PLANNING AND ZONING COMMISSION
Regular Meeting
Monday, May 31, 2016

RE: White Oak Place
Development Review No. 4
Case No. PZ 14-16

**SITE PLAN
 WHITE OAK
 PLACE**

**DIMENSION PLAN
 WHITE OAK PLACE**

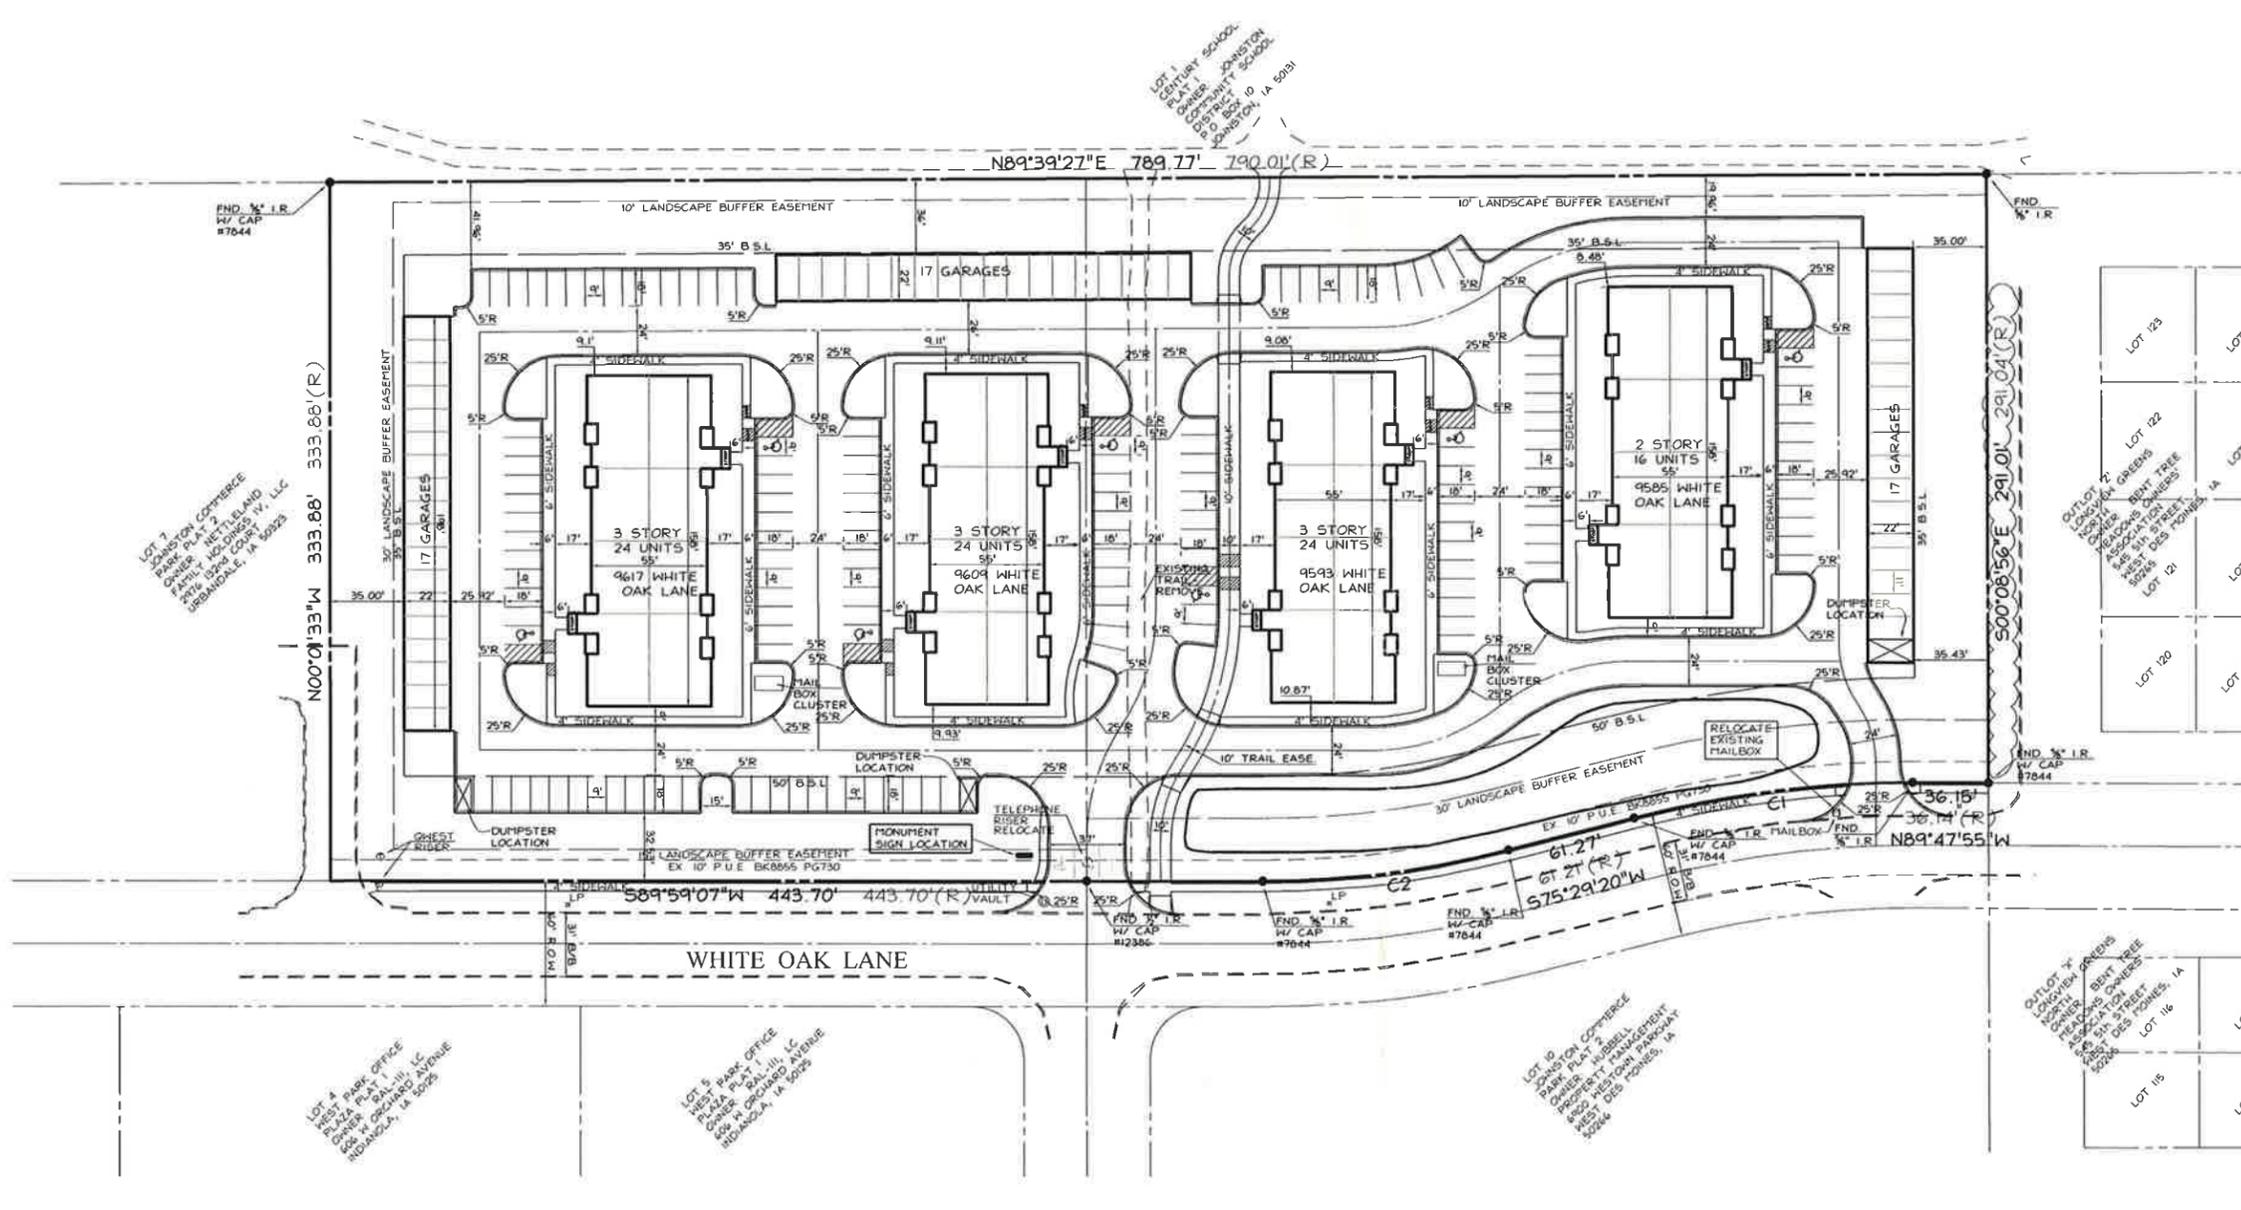
3. Provide ADA compliant connection from sidewalks to cluster box units.

APPROVED: _____ INITIALED: _____ AS-BUILT: _____
 GRADING PLAN
 WHITE OAK PLACE
 SHEET 2 OF 4

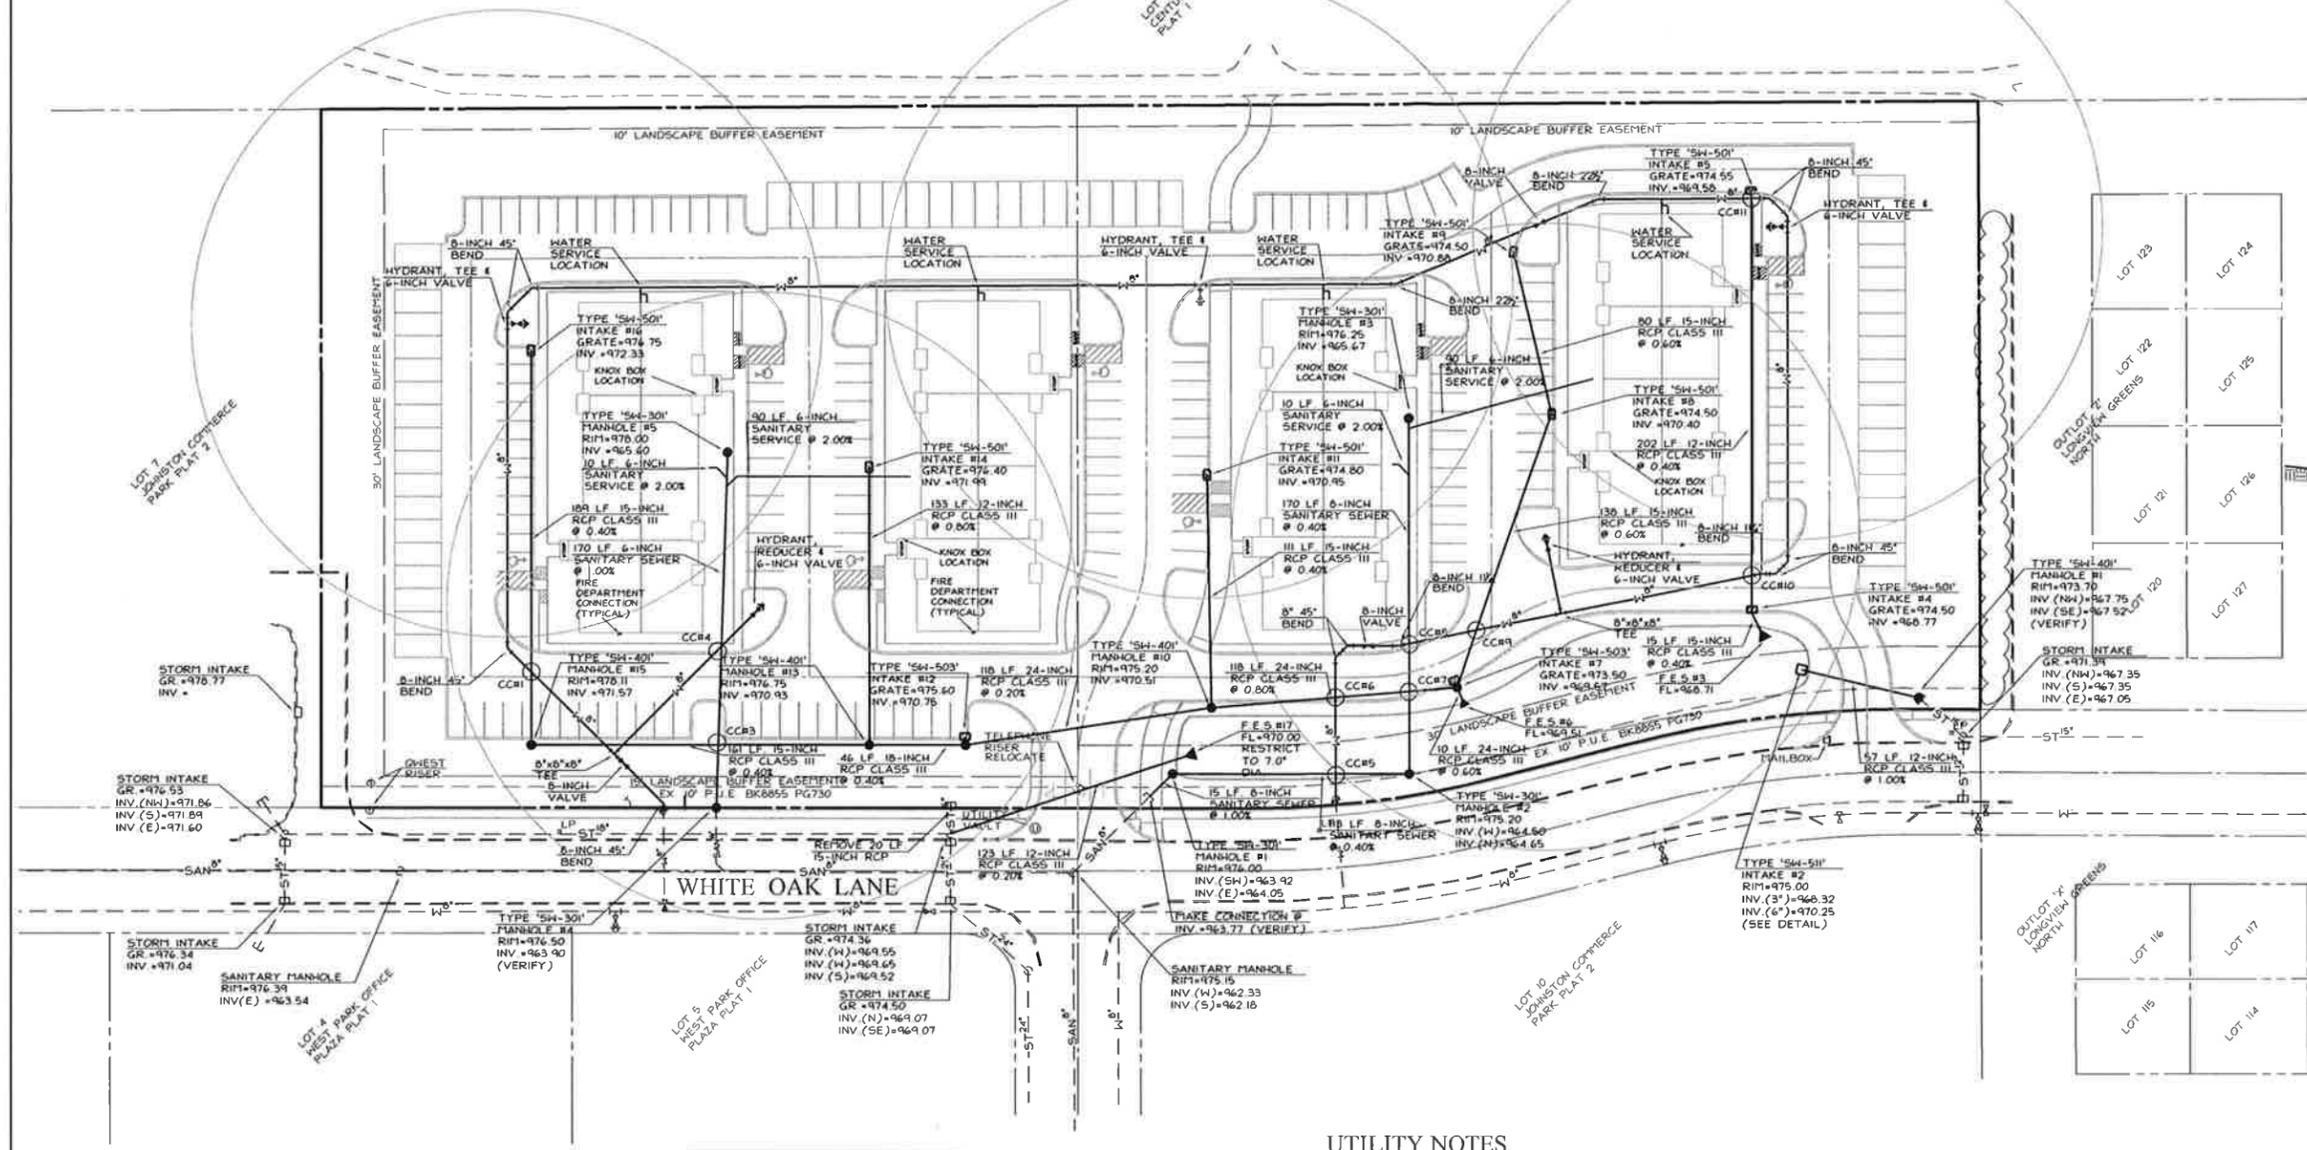
4. Provide spot elevations to document connections from sidewalks to Cluster box units are ADA compliant.
5. Note 4 shall be modified to ensure at least 8” of topsoil is put back within the right of way.
